# SAFETY RECALL

Volvo Trucks North America

Date	Number	Release	Page
07. 2023	RVXX2307	01	1 (4)

## Steering Gearbox Fastener Re-Torque

**Relaxed Tightening Torque**

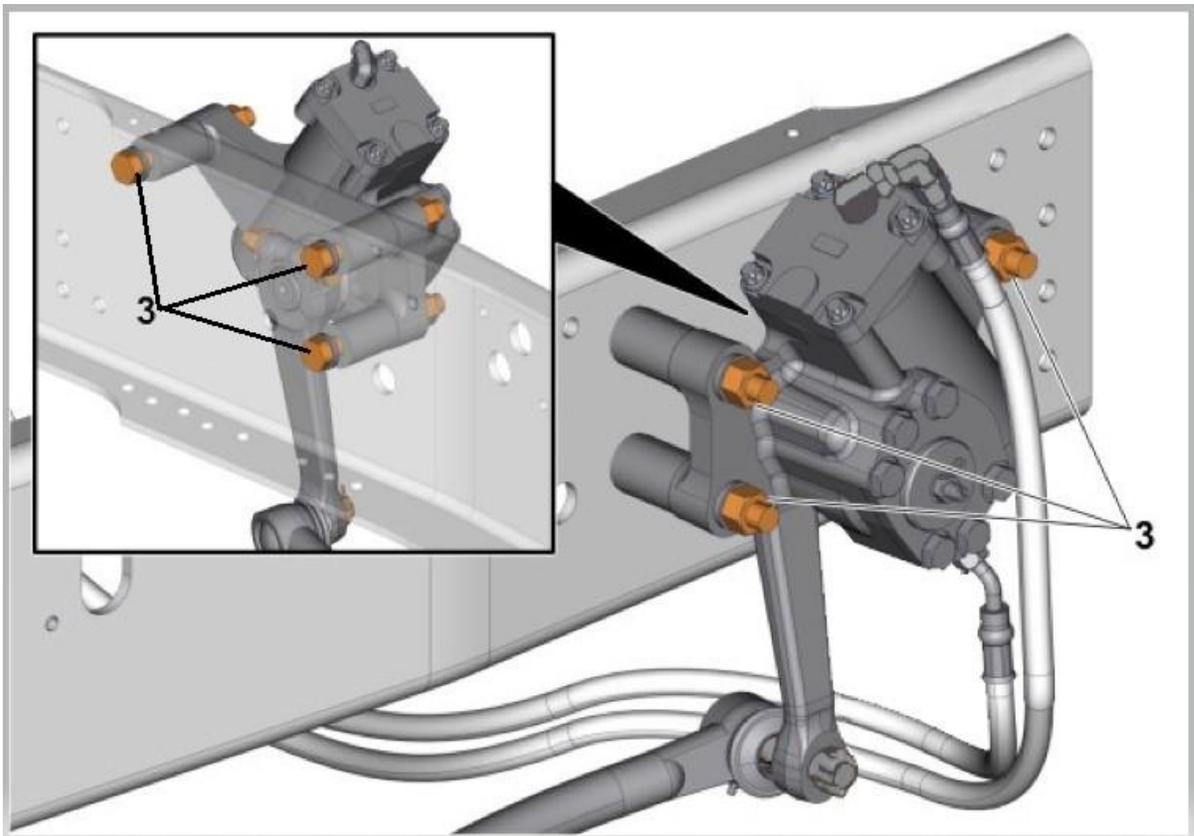
7. Set torque wrench to  $275 \pm 15$  Nm. Check relaxed torque in tightening direction.

- a. If found loose, check both bolt and nut for damage.
  - i. If damage is found on hardware, replace both bolt and nut.
  - ii. If no damage is found on hardware, replace nut only.
- b. Tighten to install torque and angle of  $200 \pm 10$  Nm + angle  $145^\circ \pm 10^\circ$ .

**Install Tightening Torque**

$200 \pm 10$  Nm + angle  $145^\circ \pm 10^\circ$
